File: RM190790 Silent One ID:

Further Information Request for Resource Consent Application Nos. RM190790, RM190789, RM190791 & RM120928V2 - Integrity Care Group - Olive Estate

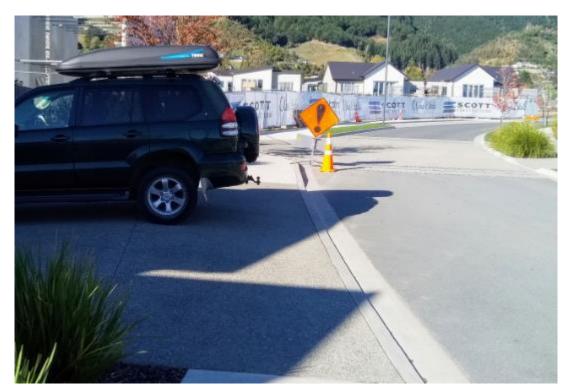
- Please amend the plans to remove the 90-degree car parking spaces from Fairose Drive as this parking layout is not supported by the Council from a traffic / pedestrian safety point of view. Parallel car parking spaces may instead be considered. Please also update the parking calculations accordingly.
- The distance between the garage doors of some of the residential units and the back of the footpath is not sufficient for larger vehicles (as demonstrated below in the existing Olive estate development):

I note that a comparable driveway length is shown for a number of the residential units in the extended part of the development. This is not supported because it poses a safety risk to pedestrians, prams and mobility scooter users that may be forced off the footpath and onto the road to pass the 'overhanging' vehicles. The distance between the buildings and the back of the footpath should be at least 5 metres. Please address.
